TRANS/WP.29/GRRF/2005/11  
1 July 2005

World Forum for Harmonization of Vehicle Regulations (WP.29)

PROPOSAL FOR DRAFT AMENDMENTS TO REGULATION No. 117

(Tyre rolling sound)

Example 2, amend to read:

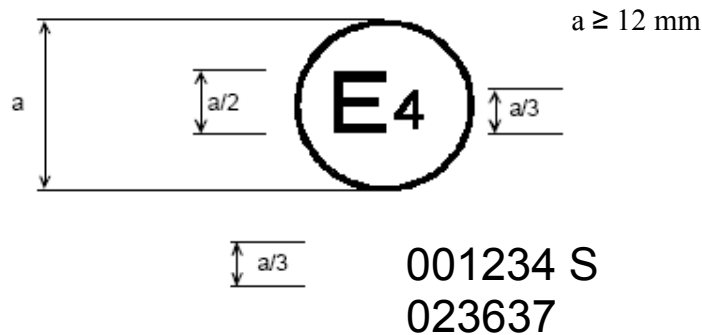
The above approval mark shows that the tyre concerned has been approved in the Netherlands (E4) pursuant to **Regulation No. 117 (marked by S (rolling sound) only) and Regulation No. 30**. The first two digits of the approval numbers indicate that, at dates when the respective approvals were granted, Regulation No. 117 was still in its original form, but Regulation No. 30 included the 02 series of amendments."

Example 3, amend to read:

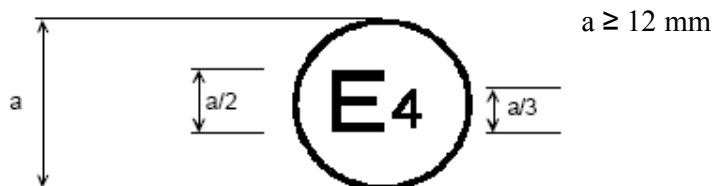
The above approval mark shows that the tyre concerned has been approved in the Netherlands (E4) pursuant to Regulation No. 117 (marked by **S (rolling sound) or W (wet adhesion) or both SW**), under approval number **011234**. This indicates that the approval is for **S (rolling sound), W (wet adhesion) or both SW**. The first two digits of the approval number (**01**) indicate that the approval was granted according to the **01 series of amendments**."

"Example 4

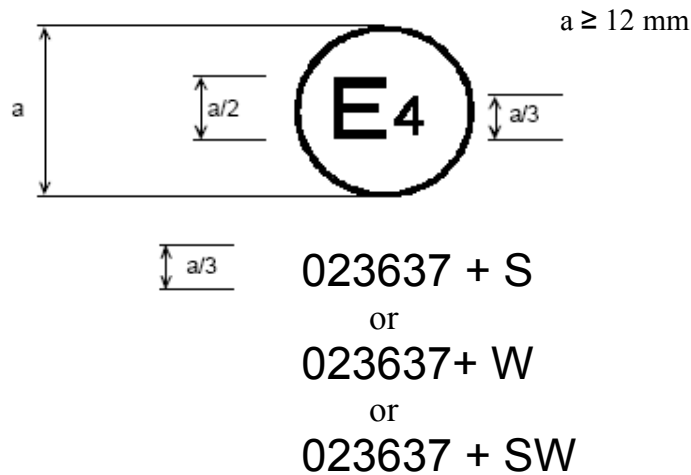
The above approval mark shows that the tyre concerned has been approved in the Netherlands (E4) pursuant to Regulation No. 117 (marked by S (rolling sound) or W (wet adhesion) or both SW), under approval number 011234. This indicates that the approval is for S (rolling sound), W (wet adhesion) or both SW. The first two digits of the approval number (01) indicate that the approval was granted according to the 01 series of amendments, but Regulation No. 30 included the 02 series of amendments.

**Example 6**

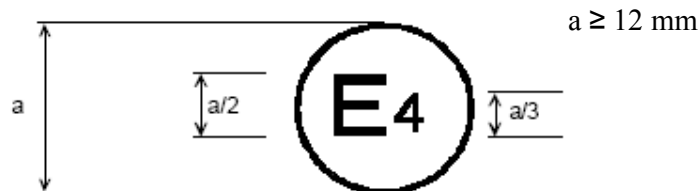
The above approval mark shows that the tyre concerned has been initially approved in the Netherlands (E4) pursuant to Regulation No. 30 and the 02 series of amendments under approval number 023637. This indicates that the approval is for S (rolling sound), W (wet adhesion) or both SW. The S, W or SW followed by (01) indicates that it has had its approval extended under Regulation No. 117 which included the 01 series of amendments. The first two digits of the approval number (02) indicate that the approval was granted according to Regulation No. 30 which included the 02 series of amendments. The addition (+) sign indicates that the first approval was granted in accordance with Regulation No. 30 and has been extended to include Regulation No. 117 approval(s).
